This letter is an objection, pursuant to 36 CFR §218, to the Lost Creek-Boulder Creek Landscape Restoration project, on behalf of the Alliance for the Wild Rockies and Native Ecosystems Council (collectively, "AWR"). The Responsible Official is Payette National Forest Supervisor Keith Lannom. The Lost Creek-Boulder Creek Landscape Restoration project is planned for the New Meadows Ranger District of the Payette National Forest (PNF).

OBJECTION STATEMENT: The EA is not in compliance with 36 CFR § 212 subpart A.

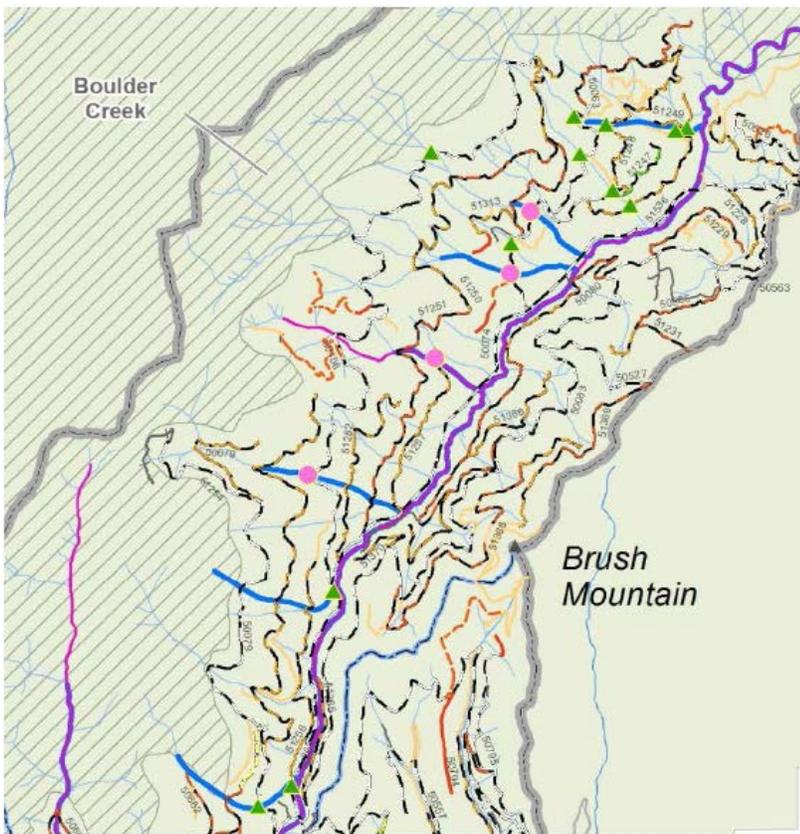
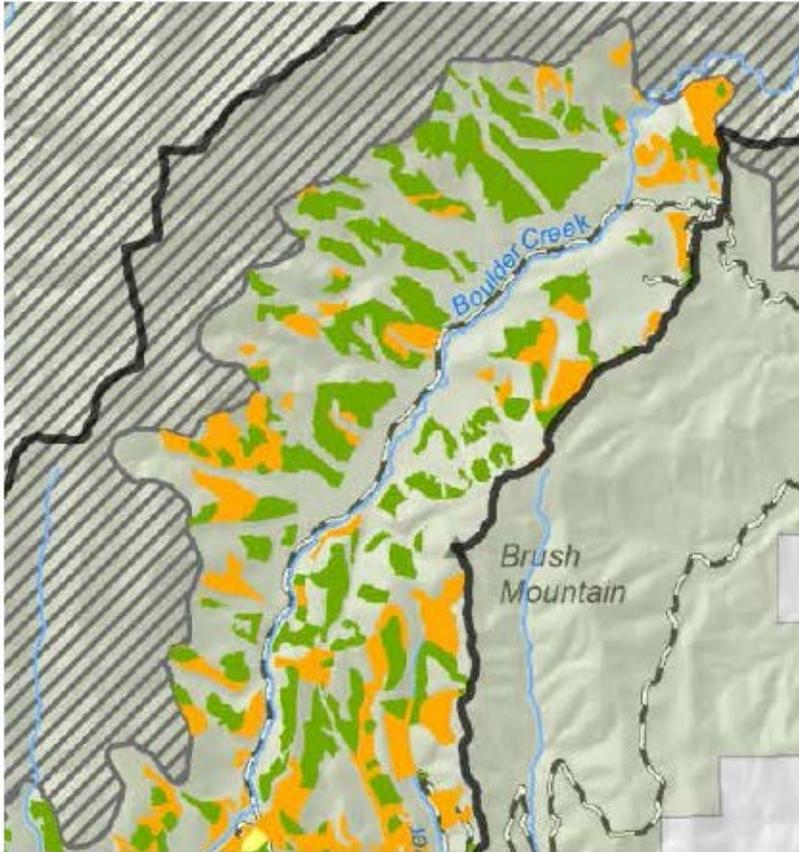
(Appendices – 83, emphasis added.) We don’t find a section in the FEIS entitled “Roadless Area Analysis and Analysis of Unroaded Lands Contiguous to Roadless Areas.” Instead, FEIS section 1.13.6. is entitled simply “Inventoried Roadless Areas.” Clearly the FEIS completely ignored AWR’s comment specific to unroaded areas adjacent to the IRA, and in regards to impacts on roadless areas generally. Since the FEIS presents no analysis whatsoever on this issue, the figure below and on the following page help to display our concerns.

In comparing the above two figures (portions of maps found in the FEIS map packet), we're assume that the first one shows all system roads. The second shows logging units colored green and yellow. Both show Inventoried Roadless Areas in diagonal lines. It is not difficult to see that areas immediately adjacent to the IRA—not separated from it by any road or other discernable management feature—would be logged. There is plenty of federal court precedent supporting AWR in the type of analysis our DEIS comments requested. As it stands, the PNF is proposing an irretrievable commitment of unroaded lands preventing them from being considered for Wilderness designation, without any analysis and disclosure required by NEPA.

REMEDY: Prepare a Supplemental Draft EIS analyzing and disclosing the impacts on unroaded areas and on the integrated IRA/unroaded as a whole, also considering the best scientific information on the importance of roadless areas for ecological integrity.
